**Submission for Compliance with Approval Condition (d) -
the Submission of a Revised Drainage Proposal**

**Temporary Shop and Services (Motor-vehicle Showroom) and Public Vehicle
Park (Excluding Container Vehicle) with Ancillary Facilities for a Period
of 5 Years in "Village Type Development" Zone, Lots 171 S.A RP (Part)
and 171 S.B (Part) in D.D. 109, Kam Hing Wai, Kam Tin, Yuen Long, New Territories**
(Application No. A/YL-KTN/935)

Appendix I - Response-to-Comments

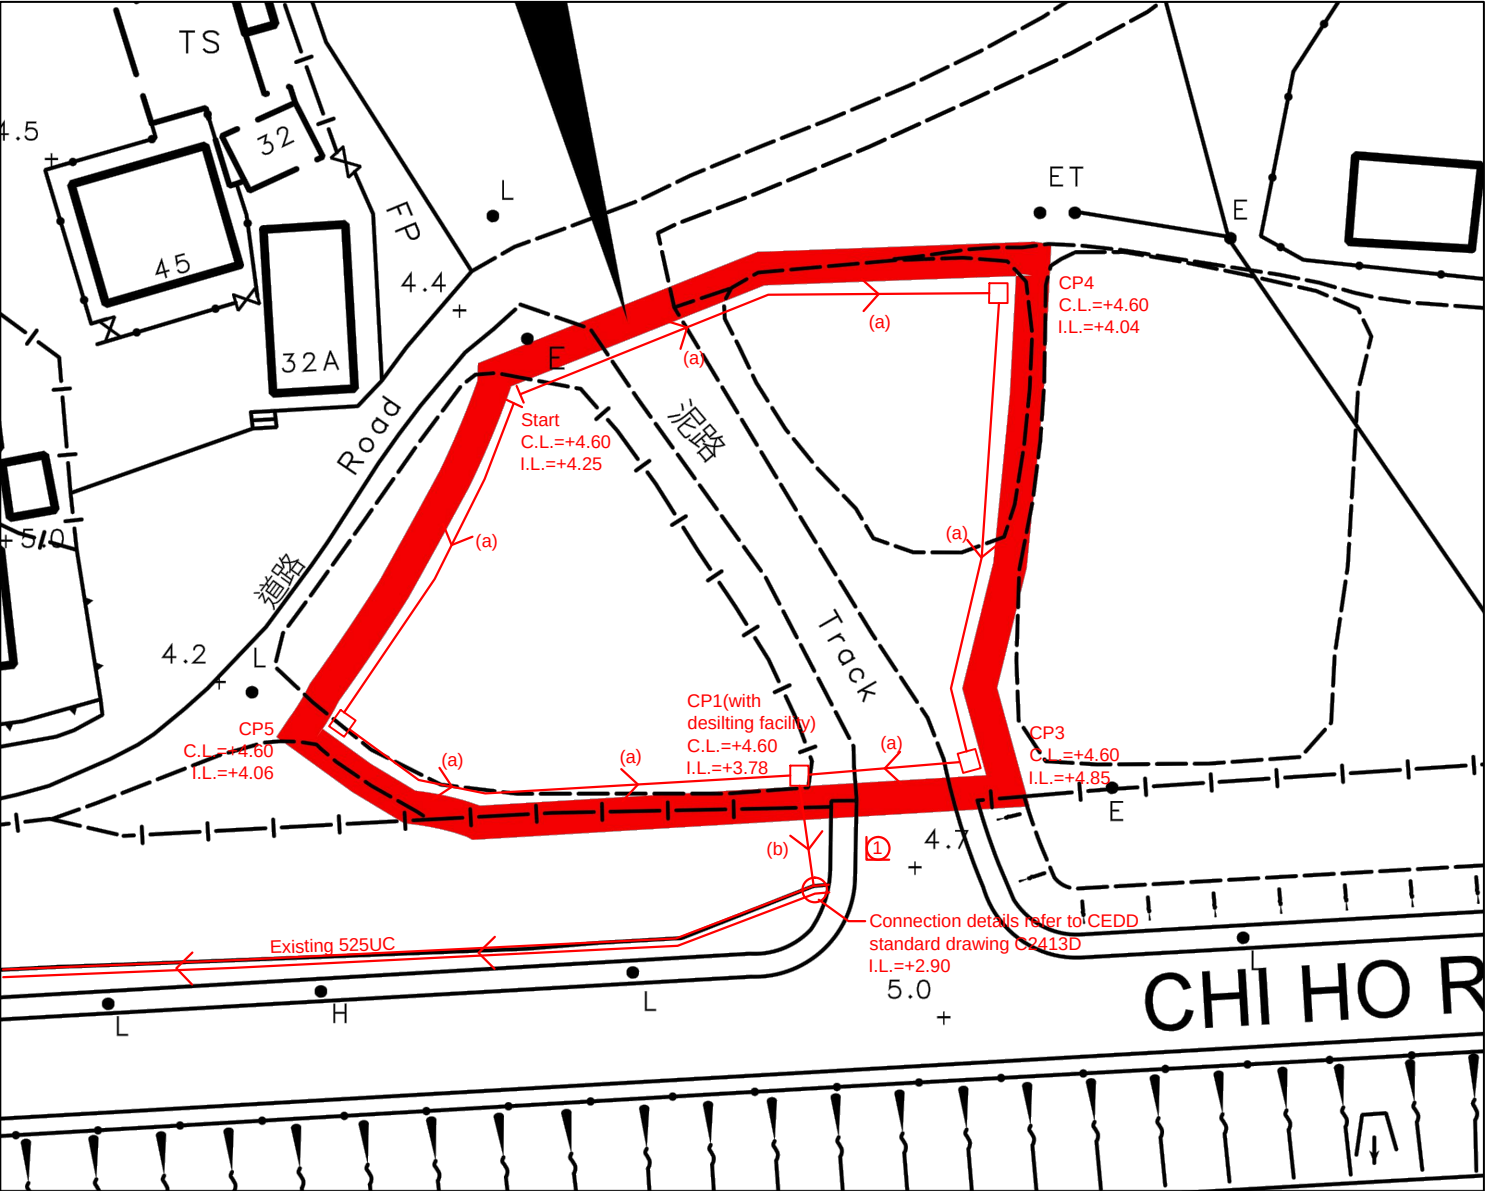
Departmental Comments		Applicant's Responses
Comments of the Chief Engineer/Mainland North, Drainage Services Department (CE/MN, DSD) (Contact Person: Mr. Terence TANG; Tel: 2300 1257)		
(a)	Checking for stepped channel is not correct. The design chart is for u-channel so please carry out appropriate checking.	Noted. Please be confirmed that TGN27 is followed for the design of SC (Appendix II).
(b)	Please be reminded that the proposed CP2 should be provided in accordance with CEDD standard drawing (i.e. surrounding wall should be provided).	Noted. Please be confirmed that CEDD standard drawing C2413D is followed for junction between SC and UC (Appendix II).

Note:
1. Catchpits (CP1) with desilting facility shall follow CEDD standard drawing No. C2406I.
2. Catchpit, UC and SC follows Typical Details of Geotechnical Manual for Slope Fig.8.10, Fig.8.11 and Fig.8.8 respectively.
3. Junction of SC and UC follows CEDD standard drawing C2413D.

Provide 300UC(1:150) or 300SC(1:25) is OK
